## NOTES AND ERRATA

POWER PLUG  
(LOOKING AT SCREWS)

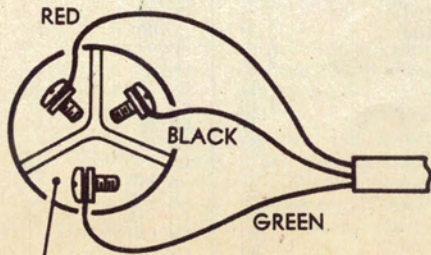
**LOW COST STEREO SYSTEM:** (January 1972, File No 1 / SA / 38). Several readers have commented on the diagram on page 39, querying the connection of the

active and neutral leads to the three pin plug. Contrary to what some readers apparently believe, there is strictly no regulation requiring that the active, neutral, or earthing conductors be connected to a plug or socket in any specific order. All that exists is a recommendation that the pins be wired in the order earth, active, neutral, in a clockwise direction, when viewed from the front of the socket. In practice, this convention will have been followed in the vast majority of installations. Since the wiring we showed does not conform to it, the black and red leads should be transposed, as shown.
